DATA SET 401A
TRANSMITTER
INSTALLATION AND CONNECTIONS

1.001 This addendum supplements Section 594-010-200, Issue 3.

1.002 This addendum is issued to revise Fig. 3 and to specify an attenuator pad to reduce the output power of the data set in compliance with FCC Tariff No. 263. To comply with this tariff, the signal level at the serving central office must be no greater than -12 dBm.

Fig. 6—Construction of External Pad

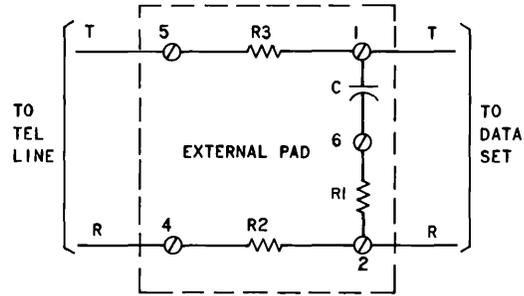
4.02 The required pad may be ordered, or made in the field, and installed in accordance with Fig. 6.
